BELLAIRE PROPERTIES INC. (CARSON'S CREEK)
PURCHASER EXTRAS

LOT # 025 P.E #002 – Model -CARLYLE - 3080 - PHASE 5

Schedule B-3 – Purchaser's Extras

MODEL: CARLYLE (3080) ELEV. A

LOT 5-27, PH5, PE002

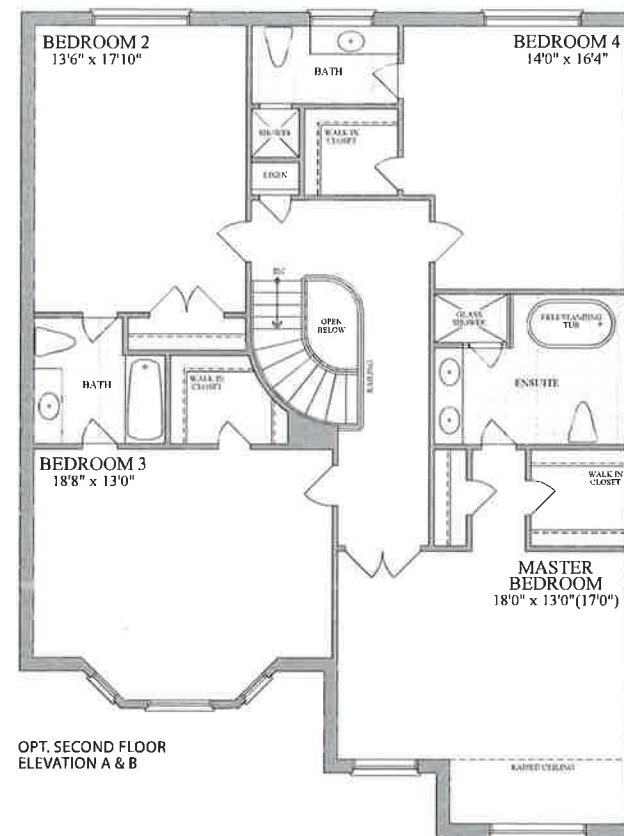
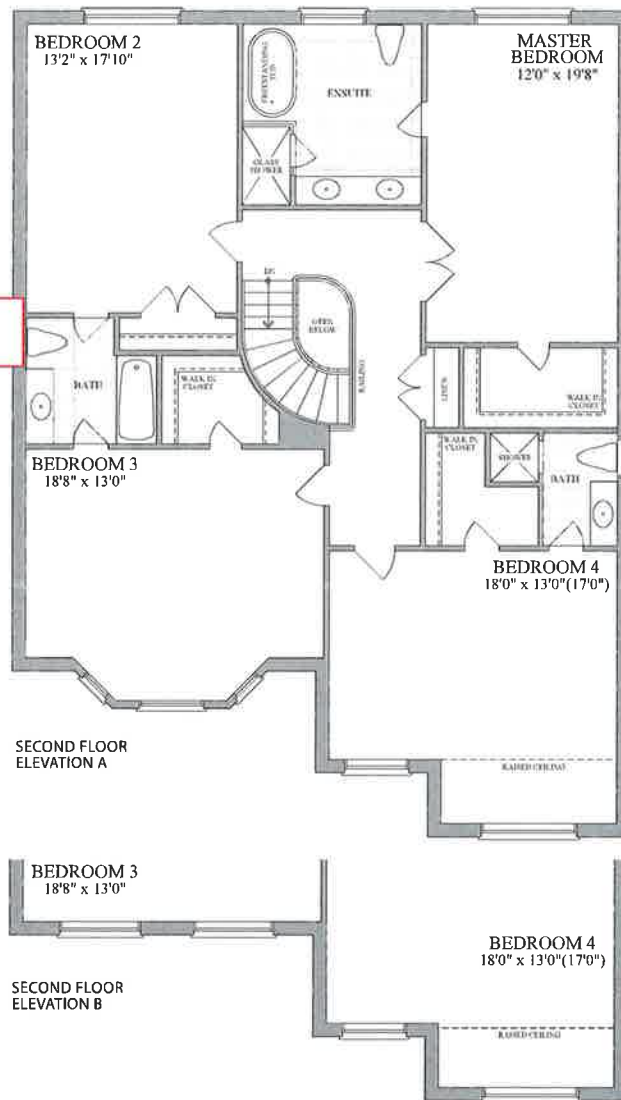
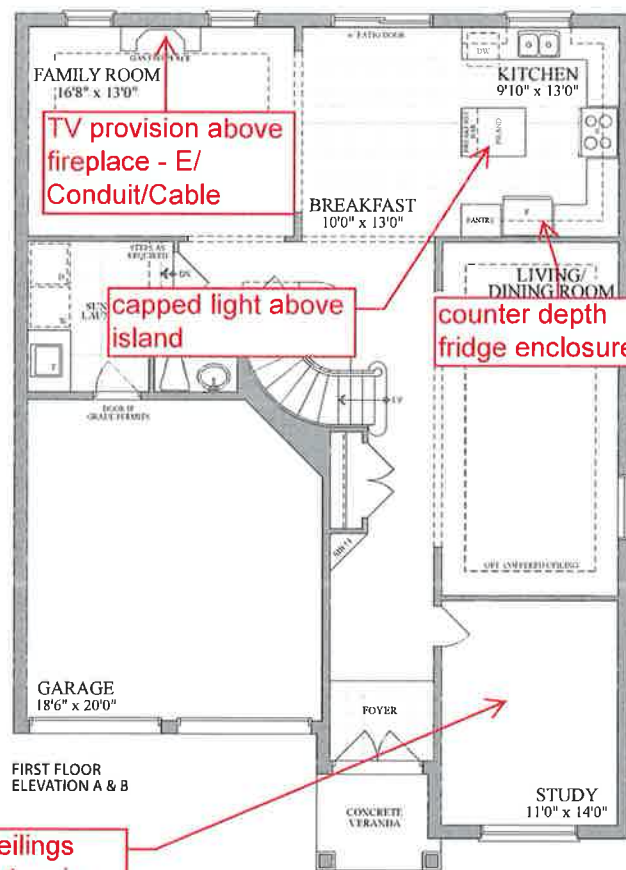
5.	Provide for smooth ceilings throughout the main floor	
6.	Basement Windows - Add two additional basement windows - standard size 30x20 white window frame. See sketch for Location
